INDEPENDENT EXPERT EVIDENCE ADVICE

WHITEHORSE CITY COUNCIL PLANNING SCHEME AMENDMENT C194

September 2017

SECTION 2
SCALE 1:500@A3

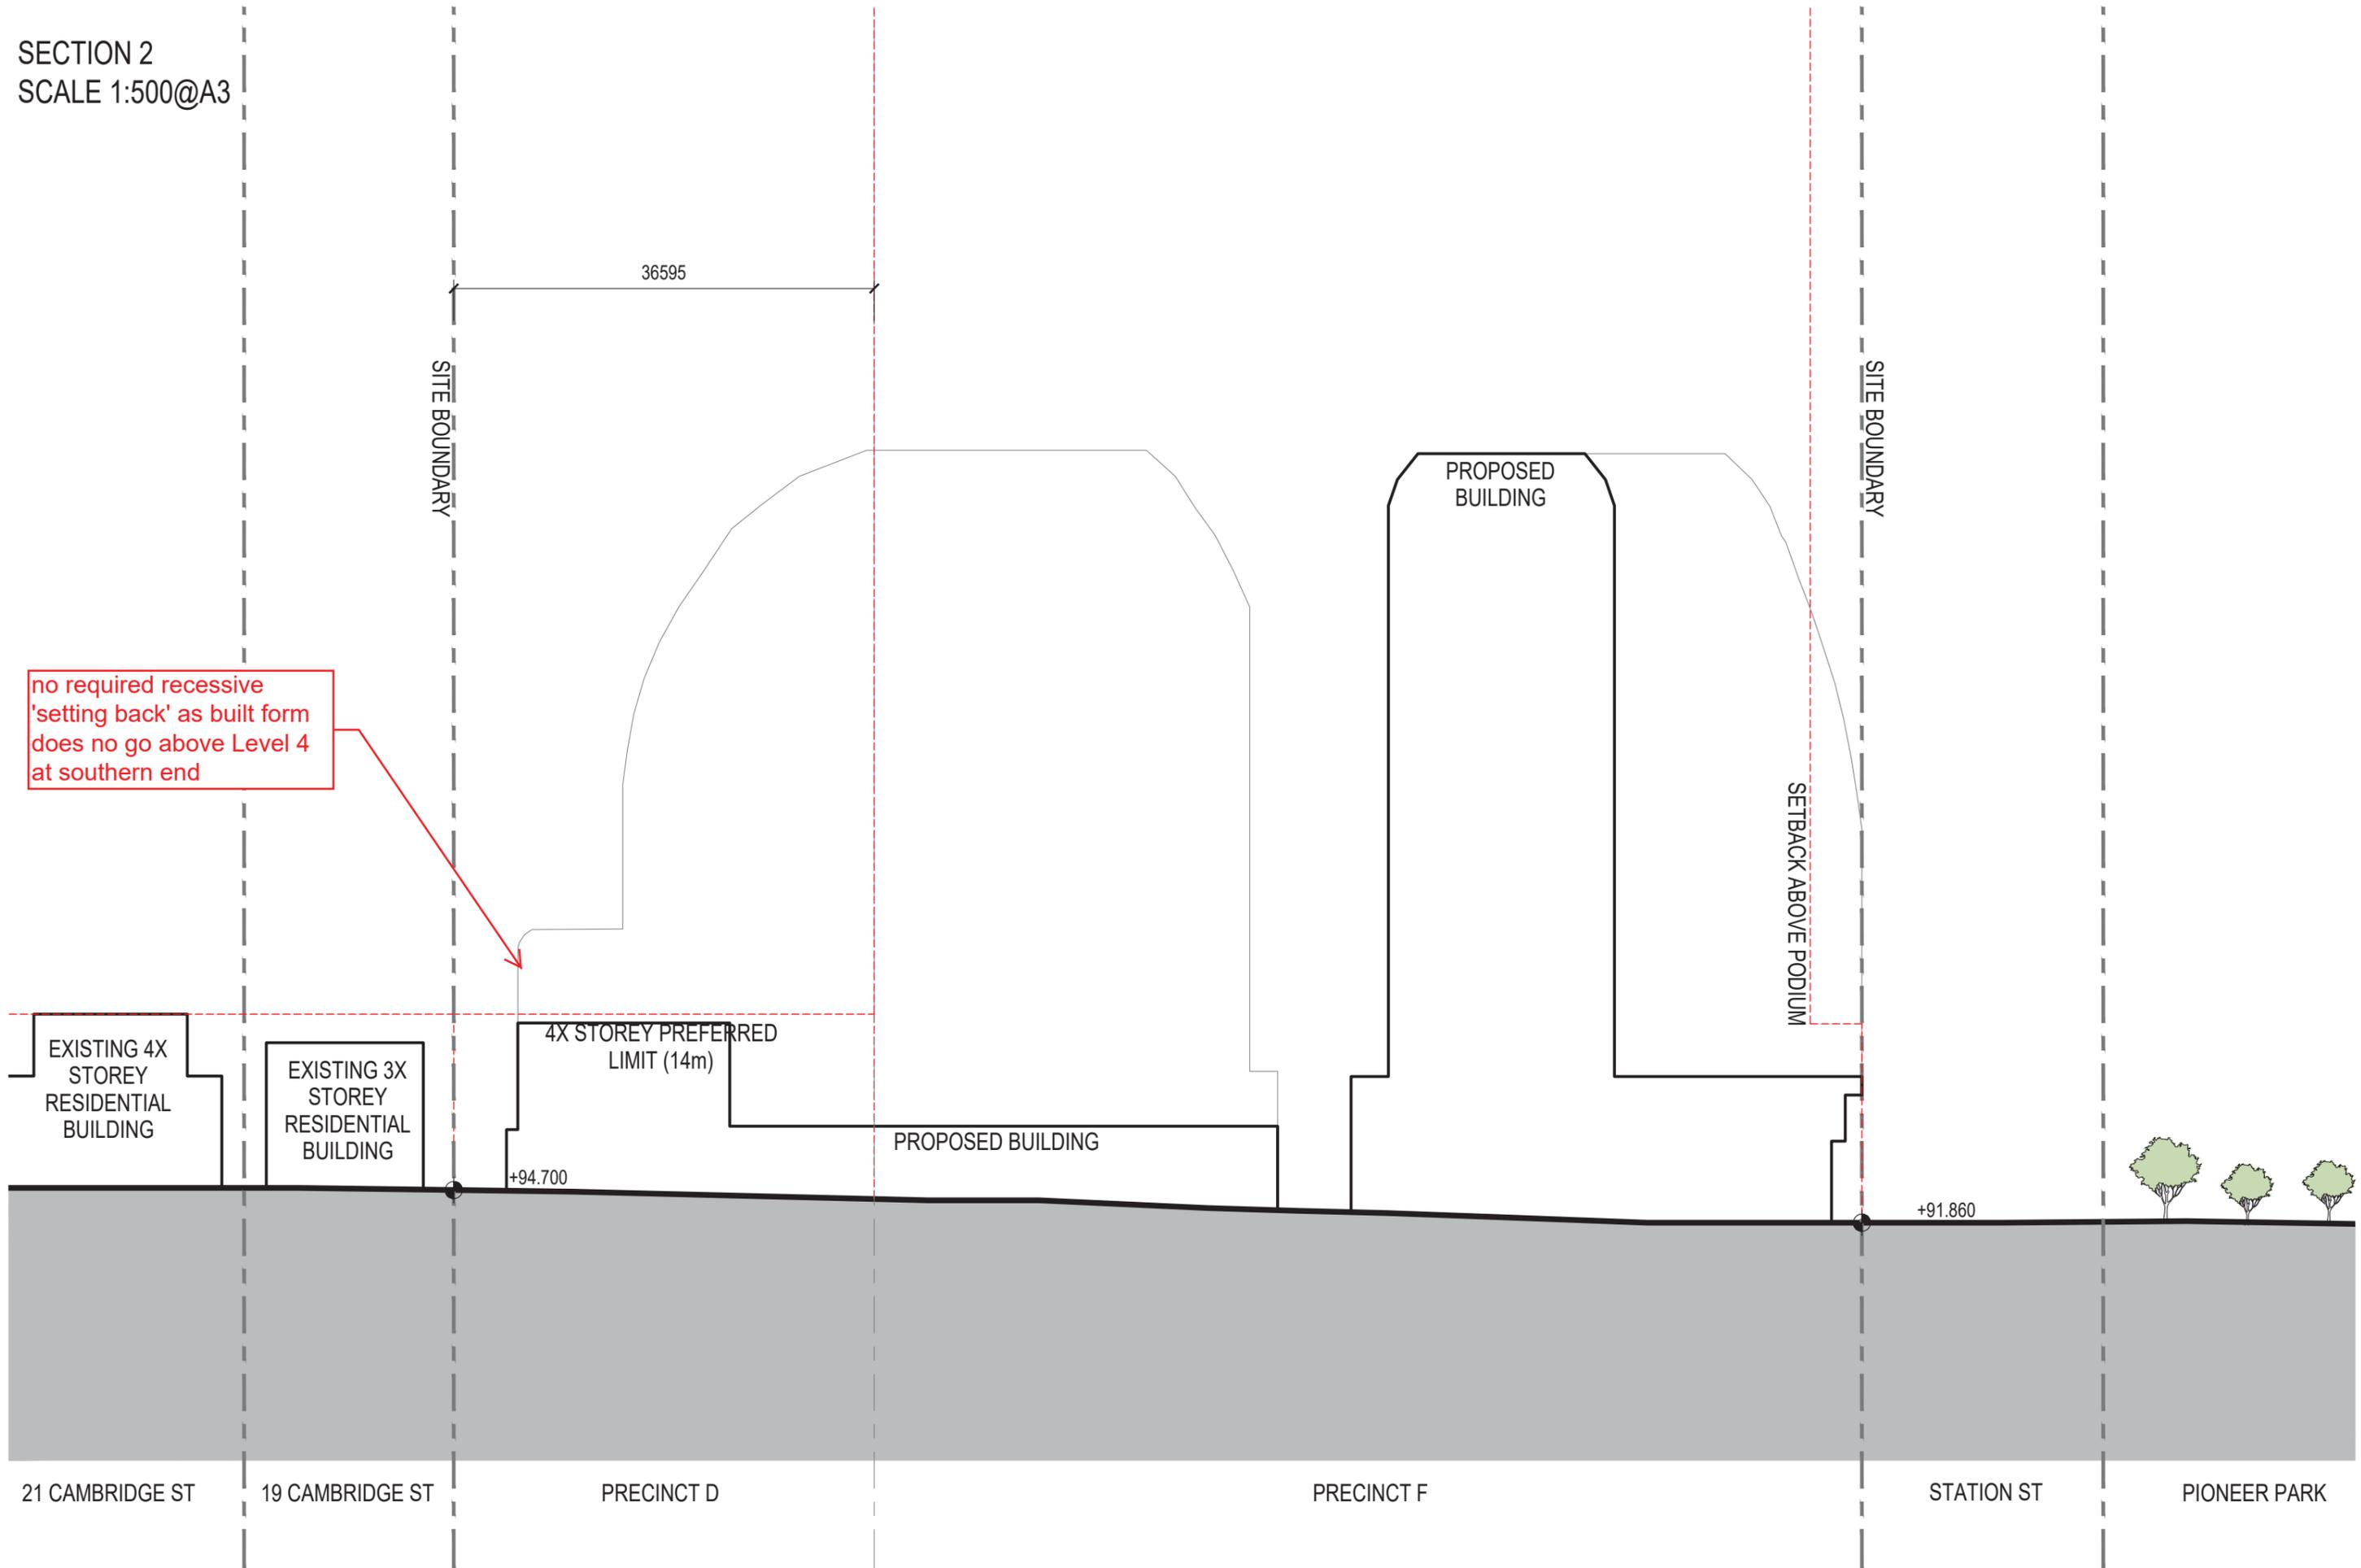
89. While I support the overall height of 6-storeys I would prefer to see a clearer transition to a 'setting back' or recessive form of Building C to the western boundary above Level 4, with a suggested increased distance to boundary of 9m at the parapet of Level 6. I have further illustrated this on Sectional Sketches.

90. The Urbis Report notes that the apartment building to the immediately west is nominally 1.6m off the boundary.
91. Based on this information I am concerned about overlooking issues between existing habitable rooms and the proposed development.

92. To avoid this issue at upper levels where the distance to the neighbouring property's windows is less than 9m screening should be required to 1.7m AFF, or as an alternative a distance of 9m should be accomplished between buildings (existing and new) so as screens can be avoided.
